The Calcutta Gazette

APPENDIX.

• NOTICES TO MARINERS.

The following Notices are republished for general information.

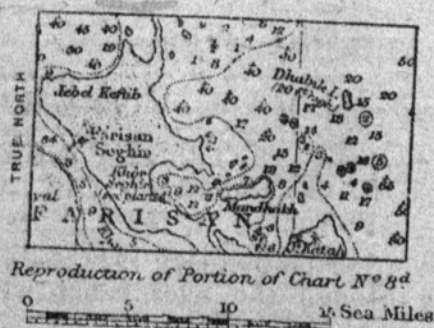
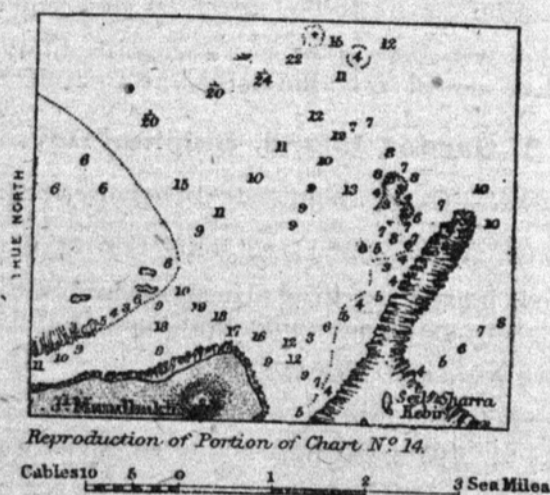
Details.—The existence of a shoal off the rocky spit northward of Jebel Katah, and corrections to the charts with regard to depths in the vicinity, are shown on the accompanying reproduction of portions of charts Nos. 14 and 8d.

Reproduction of Portion of Chart No. 2349.

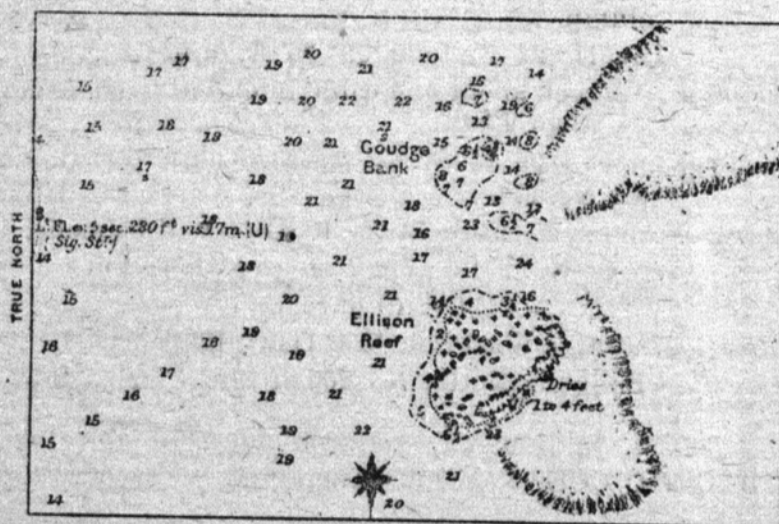
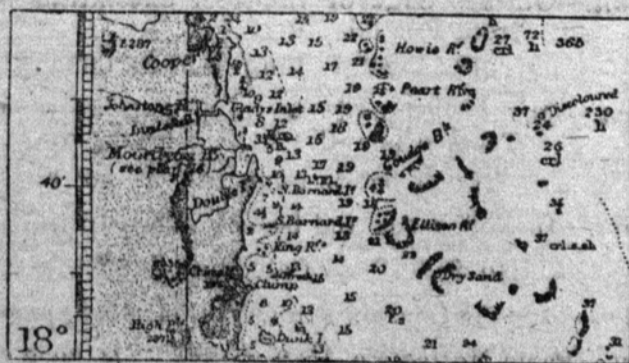
Details.—The accompanying reproductions of portions of charts Nos. 2349 and 2763 show corrections to those charts with regard to reefs and depths in the approaches to Mourilyan harbour.

Reproduction of Portion of Chart N° 3744.

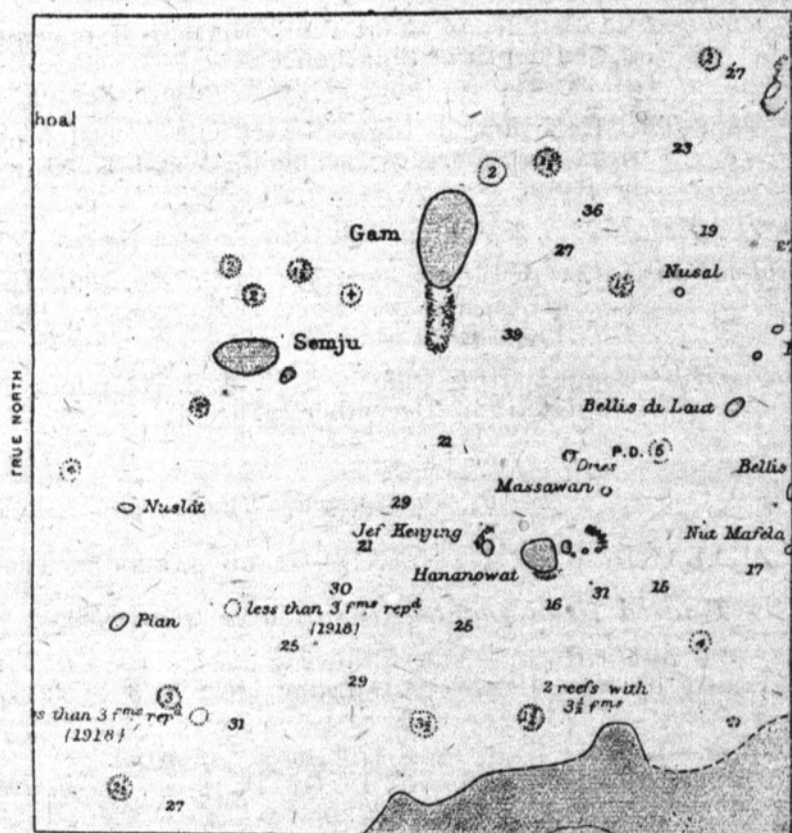
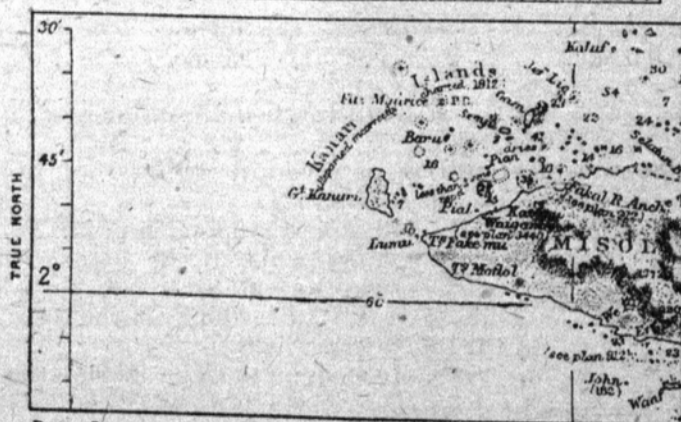
Details.—The accompanying reproduction of portions of charts Nos. 3744 and 942b shows the necessary corrections to those charts with regard to reefs in the vicinity of Gam island and off the north coast of Misoöl.

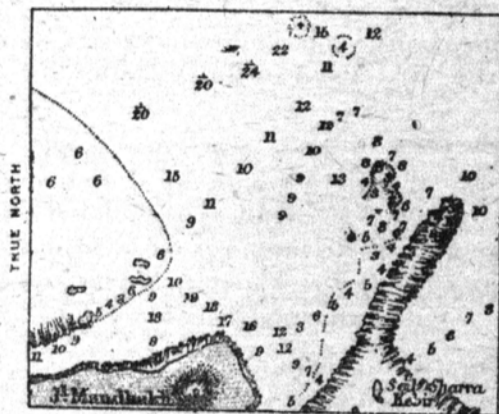
Details.—The existence of a shoal off the rocky spit northward of Jebel Katah, and corrections to the charts with regard to depths in the vicinity, are shown on the accompanying reproduction of portions of charts Nos. 14 and 8d.

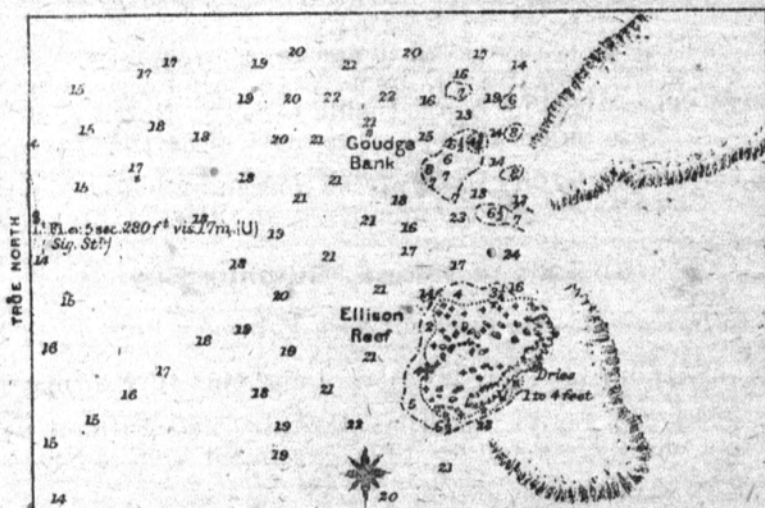
Details.—The accompanying reproductions of portions of charts Nos. 2349 and 2763 show corrections to those charts with regard to reefs and depths in the approaches to Mourilyan harbour.

Reproduction of Portion of Chart No. 930.

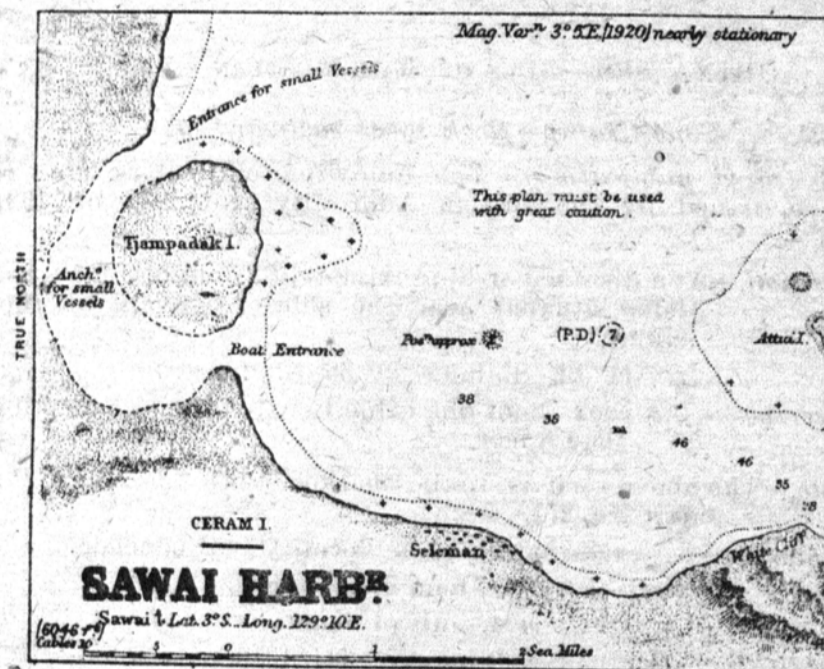
Details.—The accompanying reproduction of portion of the under-mentioned plan on chart No. 930 shows the approximate position of a 2-fathom^s ($3^m 7$) shoal in the approach to Sawai harbour, together with the extension of the reef on the eastern side of Tjampadak island.

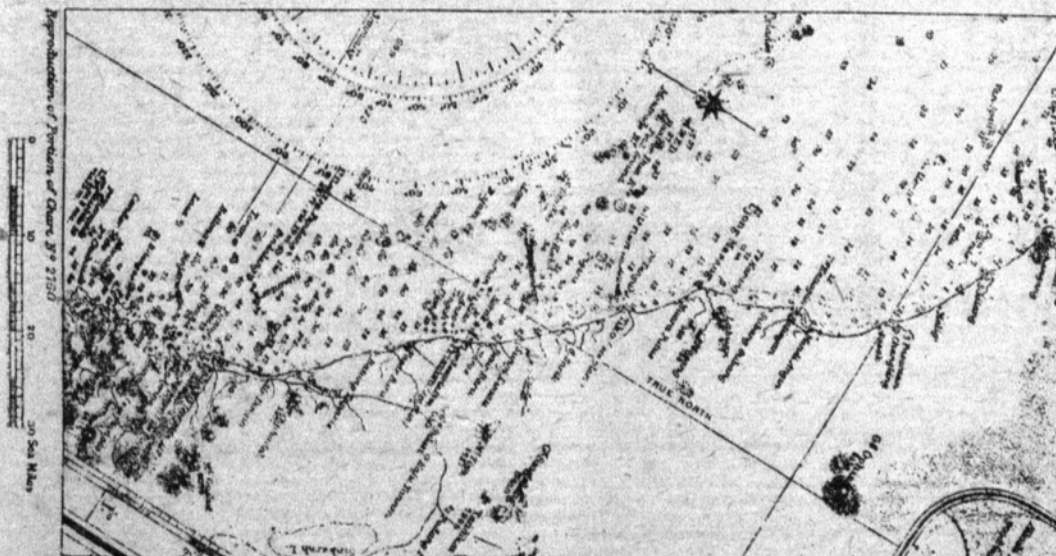
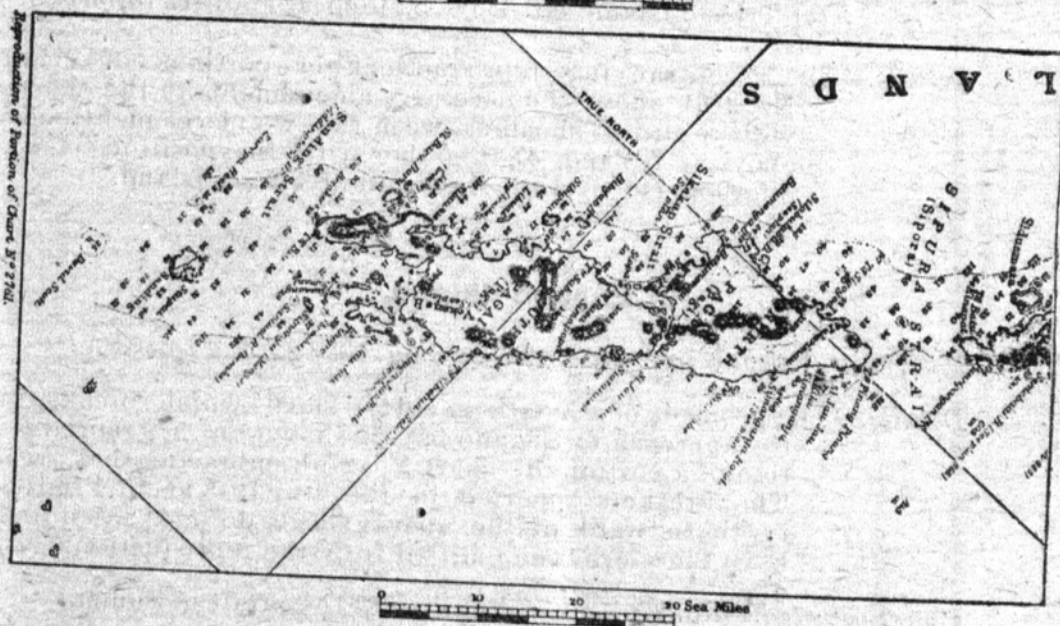
Details.—Extensive amendements to the charts with regard to Batu and Mentawi islands and the depths and shoals in vicinity, embodying the latest information received, are shown on the accompanying reproductions of portions of charts Nos. 2760, 2761 and 748b.

Reproduction of Portion of Chart No. 2761.

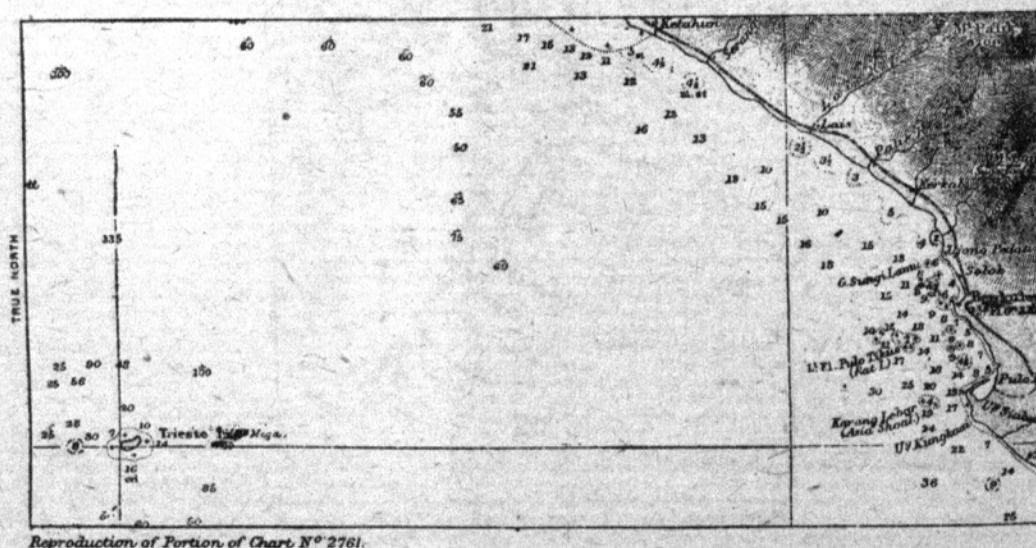
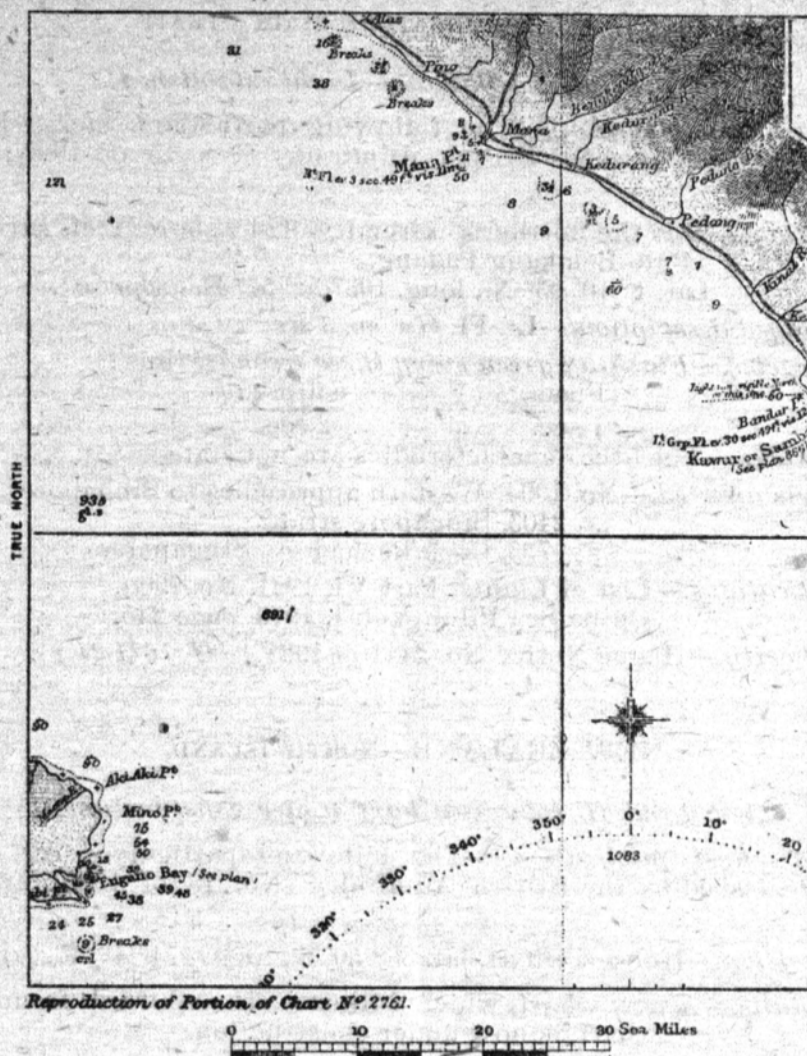
Details.—The accompanying reproductions of portions of chart No. 2761 show the necessary amendments to the charts with regard to shoals between the two places mentioned above at (a) and (b), together with the position of an 8-fathom (14^m6) shoal westward of Trieste island.

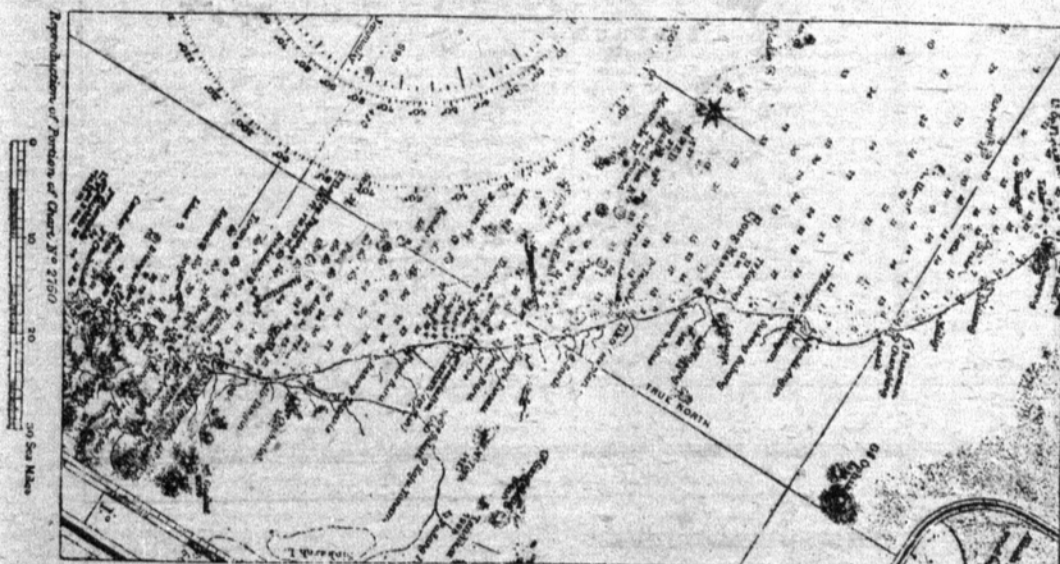
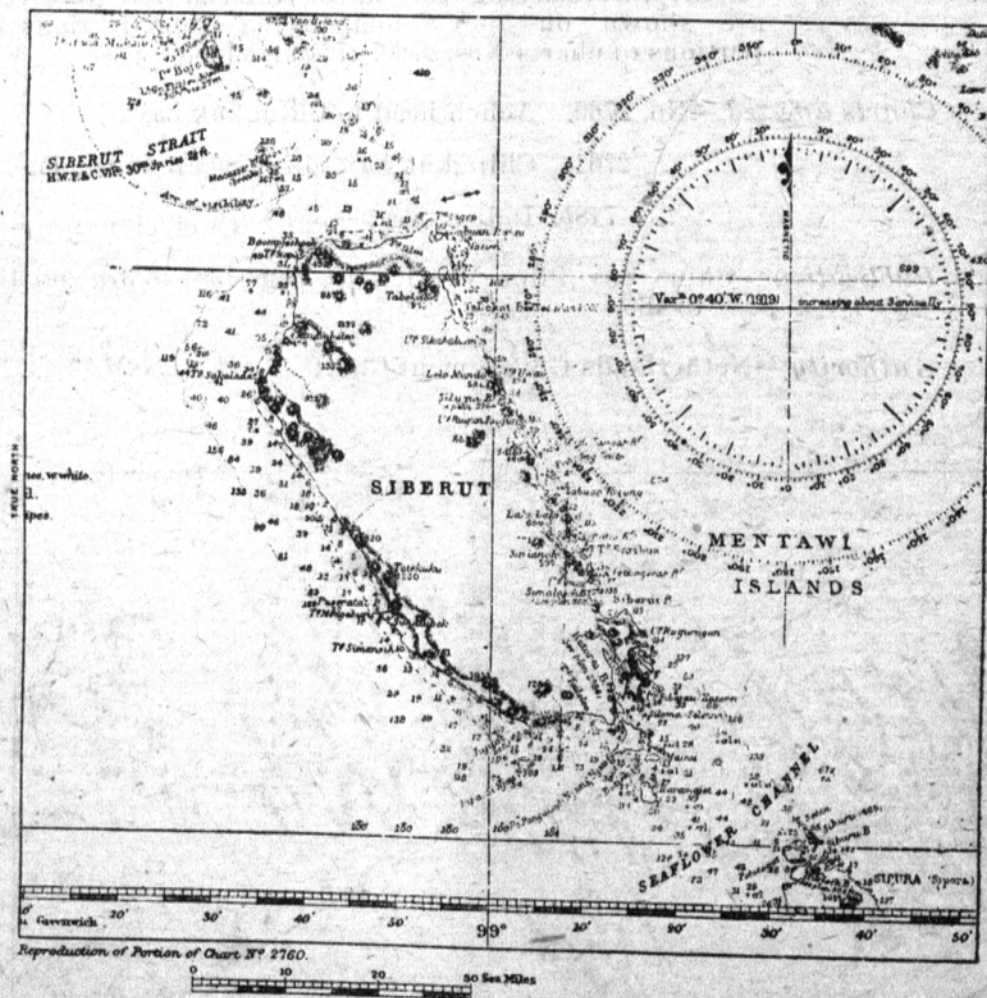
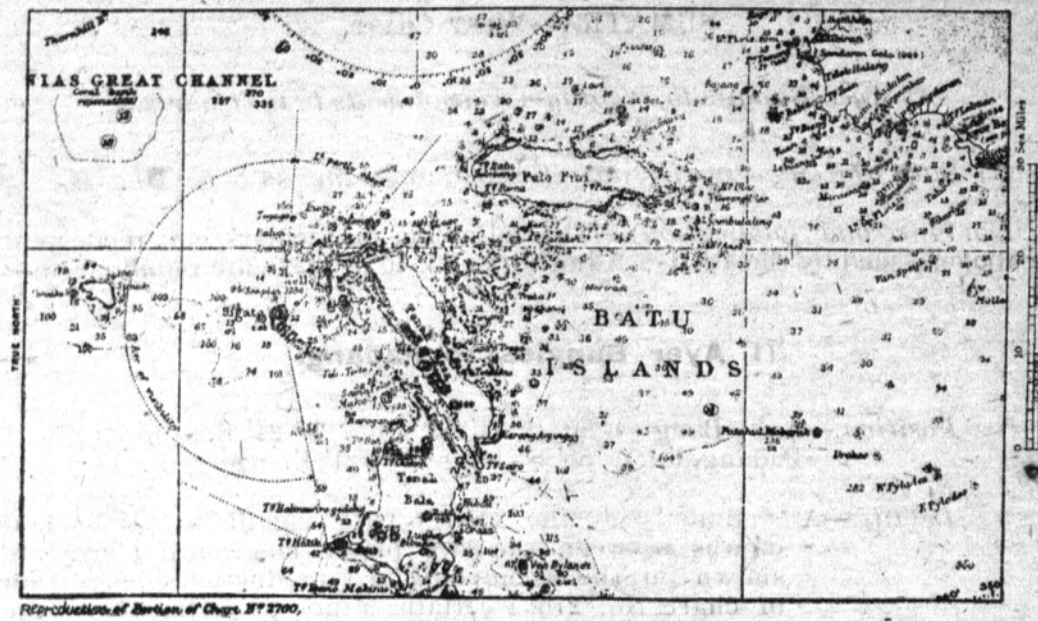
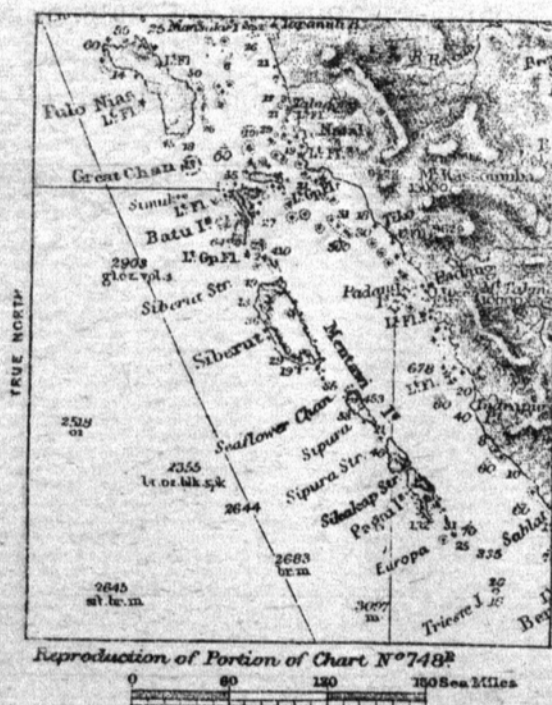
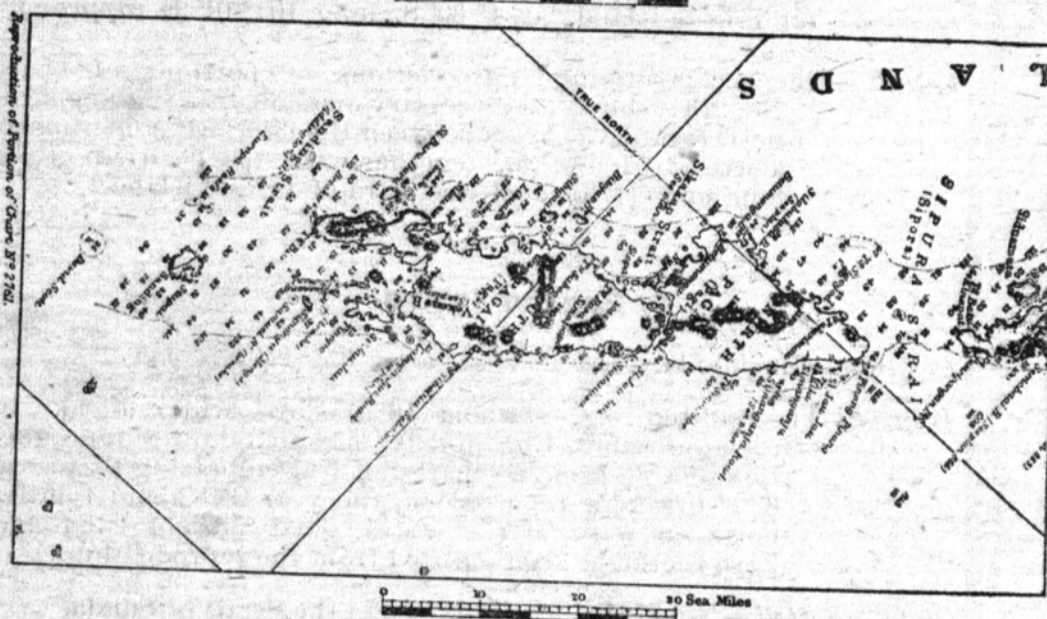
Details.—Extensive amendments to the charts with regard to Batu and Mentawi islands and the depths and shoals in vicinity, embodying the latest information received, are shown on the accompanying reproductions of portions of charts Nos. 2760, 2761 and 748b.

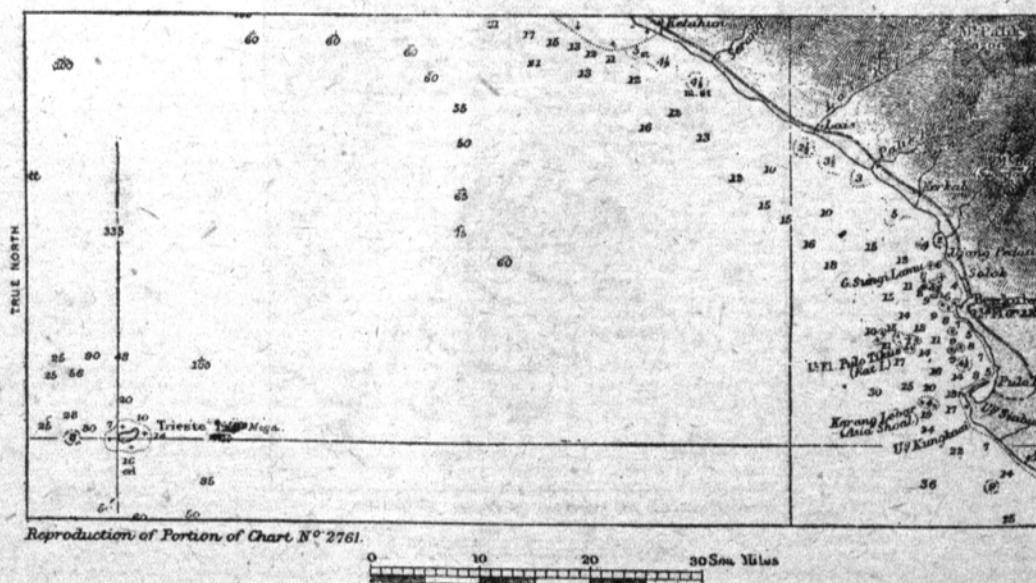
Details.—The accompanying reproductions of portions of chart No. 2761 show the necessary amendments to the charts with regard to shoals between the two places mentioned above at (a) and (b), together with the position of an 8-fathom (14^m6) shoal westward of Trieste island.
